Planning Commission

Regular Meeting Agenda

December 9, 2024 | 6:30 PM

SUBJECT: Conceptual Site Plan & Elevations, Industrial Expansion, 407 Dividend Drive

EXTERIOR ELEVATIONS

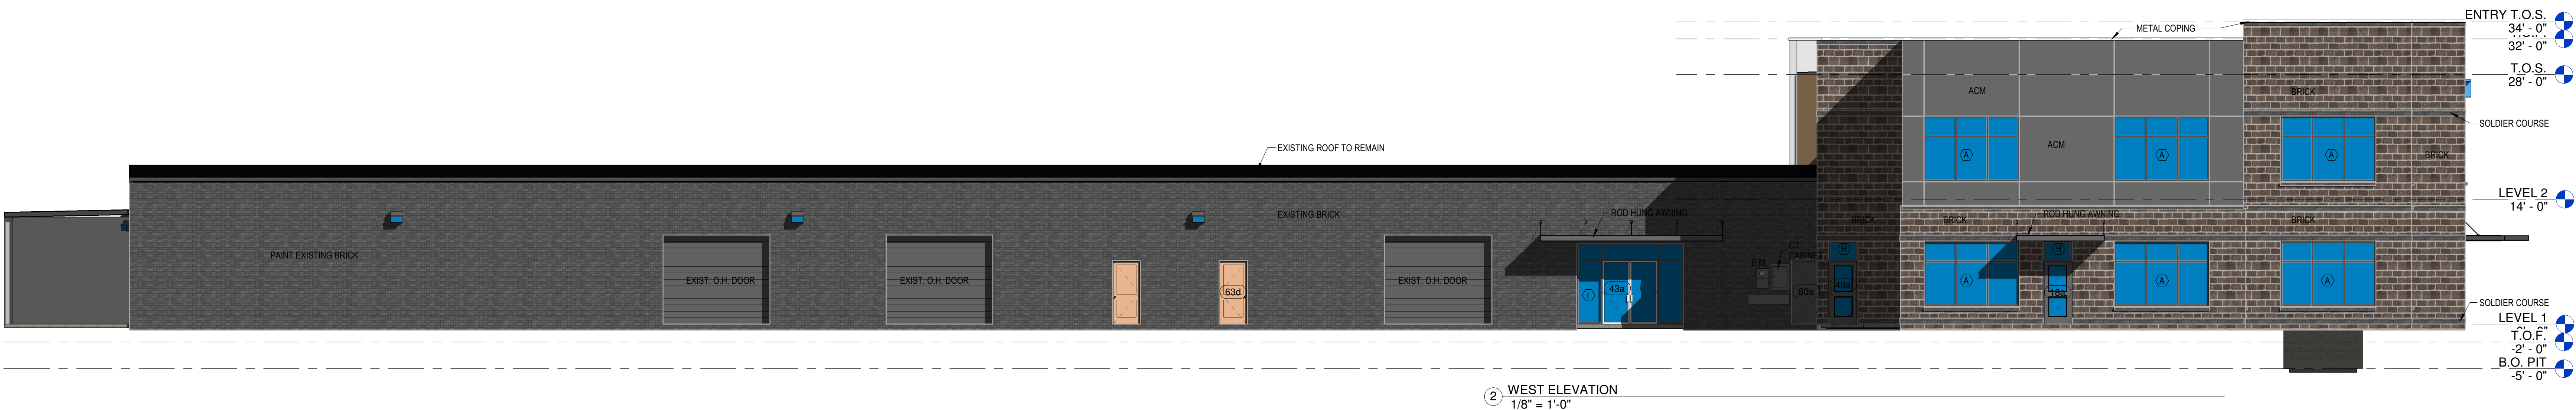
Similar to most industrial sites, the building will be steel construction faced with a combination of brick and metal panels. As a general rule, front facades should be 80% primary materials (ie. brick or stone) and side facades should be at least 50% primary materials.

Looking at just the new construction on the front of the building, the proposal is for 70% brick on the front facade, 60% on the left side, and 69% on the right side. The existing portion of the building is 100% brick on the remainder of the left side and metal on the remainder of the right side. Staff is of the opinion that the design satisfies the intent of the ordinance.

To maintain the pedestrian scale for the two-story addition, the massing of the architecture is defined by a change in materials, a change in plane, and varying heights. The inclusion of soldier courses of brick and a row of windows on the first and second levels break the facade into horizontal sections, further reducing the bulk of the building.

Sections 728 through 730 establish color requirements which states predominant colors should be neutral or earth tones. The proposed brick is a dark brown with gray undertones and the metal panels are charcoal gray. The windows will be black anodized aluminum and a black metal awning is proposed over the front door. The existing portion of the building will be painted charcoal gray to match the metal panels. The proposed color palette is:

LANDSCAPE PLAN

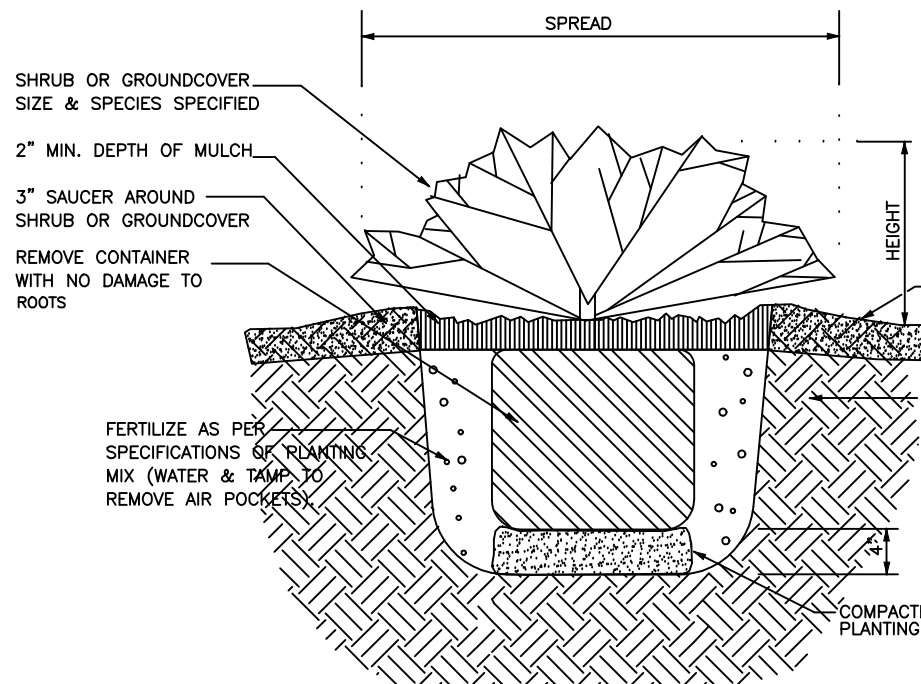
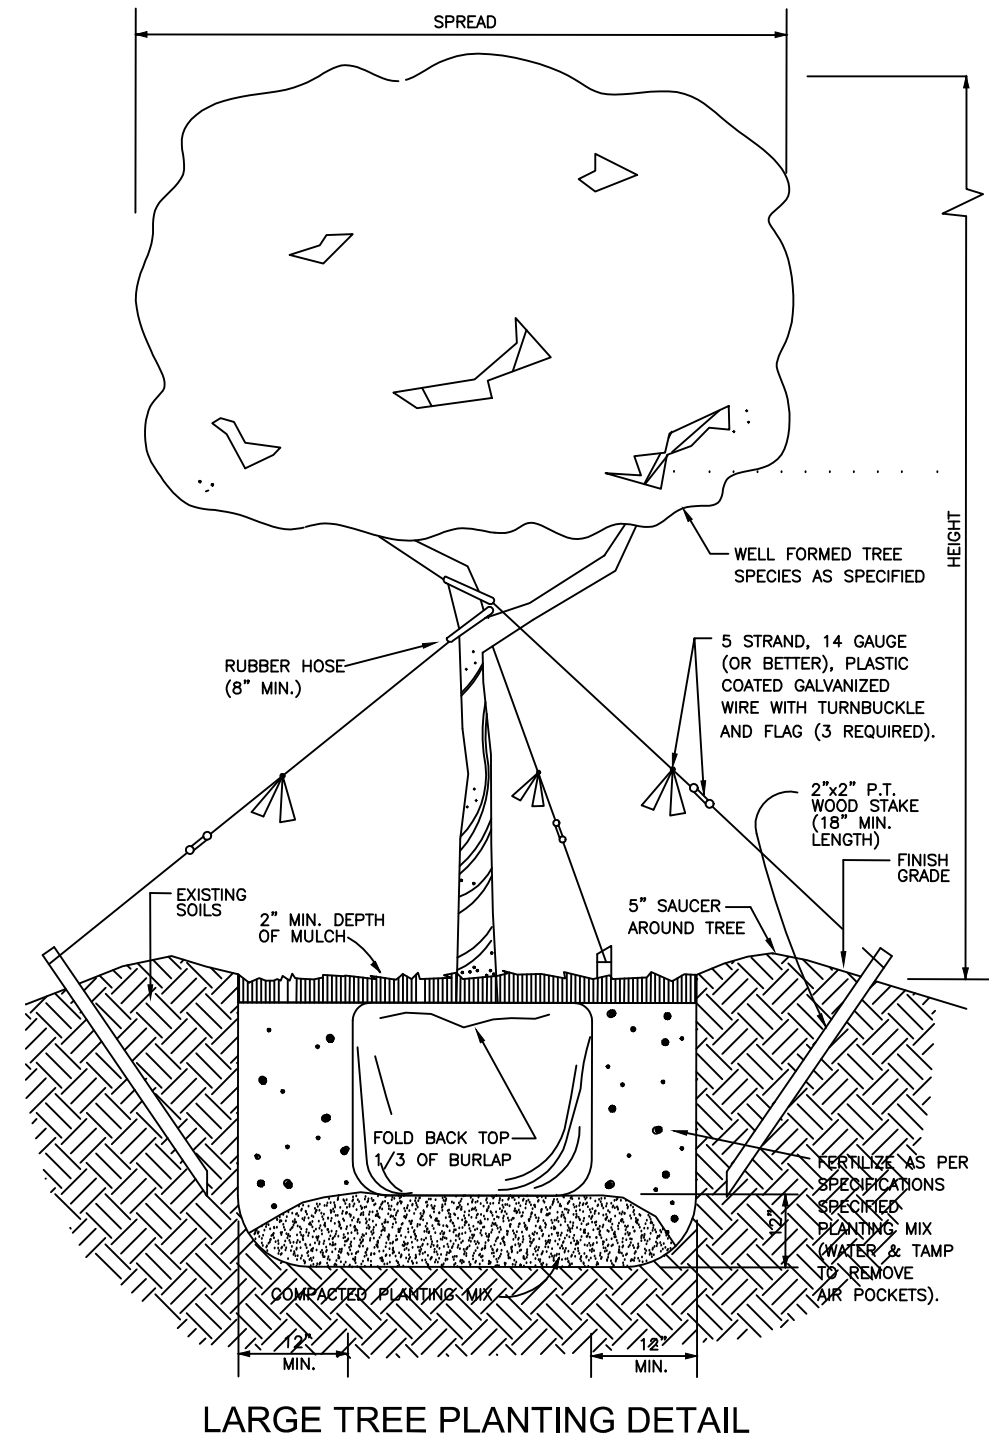
Based on the amount of new impervious surface in the development area (18,364 SF), which includes structures, drives, parking area, and sidewalks, the landscape ordinance requires a minimum of 54 caliper inches of overstory trees and 36 inches of understory trees.

The proposal is for 36 inches of canopy trees and 27 inches of understory trees. Since the total requirement has not been met, the tree fund alternative compliance method is being requested for 30% of the trees. See the table below for calculations.

Section 1114.5 of the Land Development Ordinance permits the tree fund option after all the canopy and understory trees that can reasonably be planted on the site are provided. It is the opinion of the staff that this requirement has been met.
